Office Action Summary	Application No. 10/804,573	Applicant(s) BLADEN, ROY VICTOR	
	Examiner ERNESTO GARCIA	Art Unit 3679

DETAILED ACTION

Cowles, 2,265,267

Krippendorf, 4,848,395

FIG.16

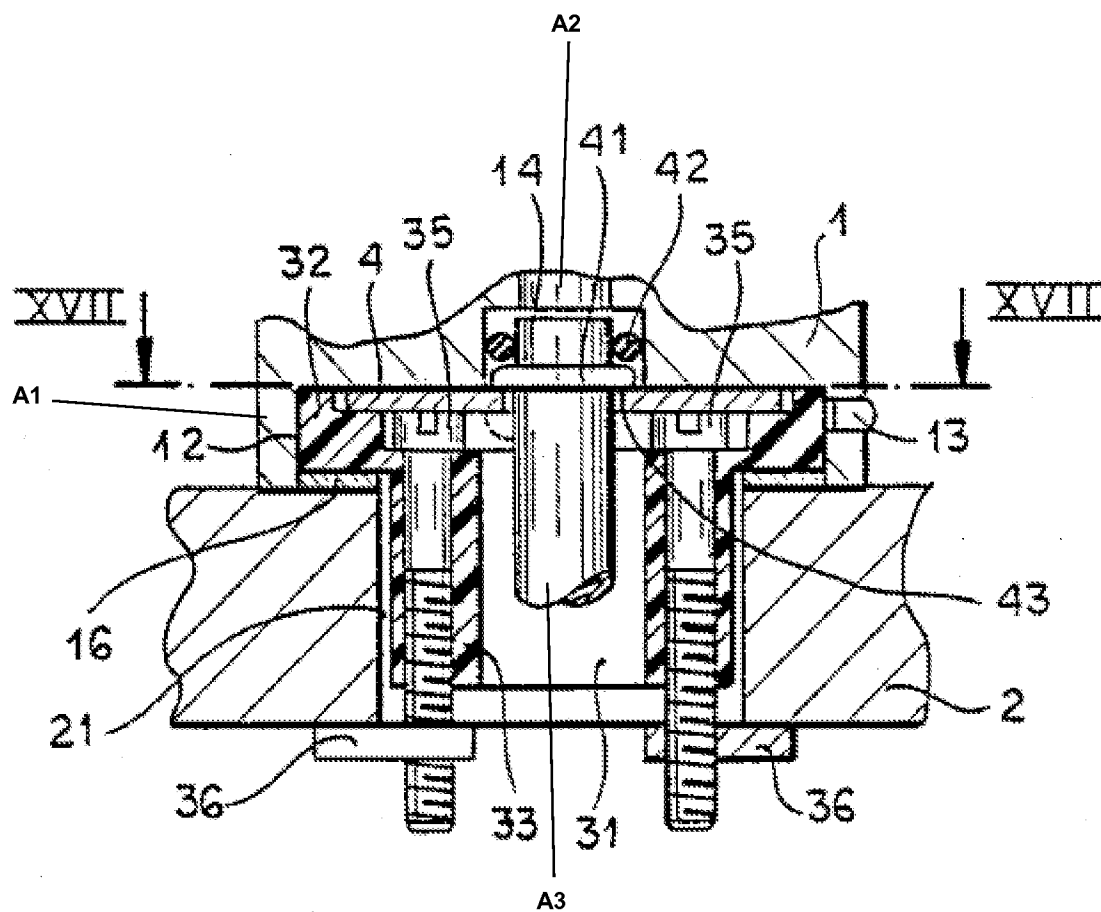
Regarding claim 1, Krippendorf discloses, in Figures 3 and 16, a quick connect assembly comprising a building element **1**, a mounting member **2**, a first locking member **A1** (see marked-up attachment), a second locking member **3**, a first conduit **A2**, and a second conduit **A3**. The first locking member **A1** is coupled to the building element **1**. The second locking member **3** is coupled to the mounting member **2**. The first locking member **A1** has a first passageway **112** extending through the first locking member **A1**. The second locking member **3** has a second passageway **31** extending through the second locking member **3**. The first locking member **A1** and the second locking member **3** have co-operative cam locking elements **11**. The first conduit **A2** and the second conduit **A3** are disposed in fluid communication. The first conduit **A2** is

disposed within a portion of the building element **1** and the second conduit **A3** is disposed on a side of the mounting member **2** (note that the conduit run beyond the mounting member) opposite first locking member **A1** or the second locking member **3**. The first conduit **A2** and the second conduit **A3** cooperatively define plumbing **14**. The plumbing **14** extends from below the mounting member **2** into the building element **1** and passes through the first passageway **12** and the second passageway **31** (see Figure 16). The plumbing **12** includes a first fitting **41** and a second fitting (not shown however, it is known that the other end of plumbing **14** has another fitting to connect to a water supply or other plumbing; see Wolfgang's Figure 3 as evidence). The first fitting **20** and the second fitting **4** are coupled to the plumbing **14**.

Regarding claim 20, Krippendorf discloses, in Figures 3 and 16, a quick connect assembly comprising a building element **1**, a mounting member **2**, an interference member **A1**, a receiving member **3**, a first conduit **A2**, and a second conduit **A3**. Services are permitted to pass between the mounting member **2** and the building element **1**. The interference member **A1** is coupled to the building element **1**. The receiving member **3** is coupled to the mounting member **2**. The interference member **A1** has a protrusion **11** (the pin). The receiving member **3** has an engagement member **11** (the slot). The first conduit **A2** and the second conduit **A3** are in fluid communication. The first conduit **A2** is disposed within a portion of the building element **1** and the second conduit **A3** is disposed on a side of the mounting member **2** opposite the second locking member **3**. The first conduit **A2** and the second conduit **A3**
